PRODUCT
SUPPORT
BULLETIN # 457

TOOL(S) \ PRODUCT(S) AFFECTED: 0724-20 ½" V28 Hammer-Driver/Drill

SUBJECT: rubber spacer attached to 23-66-1779 Service Switch

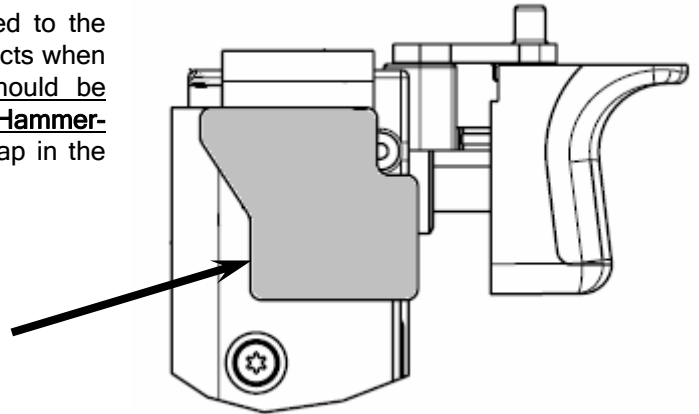
23-66-1779 is now supplied with a rubber spacer attached to the copper heat sink to reduce vibration to internal switch contacts when installed in an Impact Wrench. The rubber spacer should be removed before installing the switch into a 0724-20 ½" V28 Hammer-Driver/Drill; if the rubber spacer is not removed a slight gap in the handle halves will occur.

To reduce high vibration loads to internal switch contacts the rubber spacer is required when installing the -1779 Switch into a 0779-20, 0779-50 or 0799-20 ½" V28 Impact Wrench.
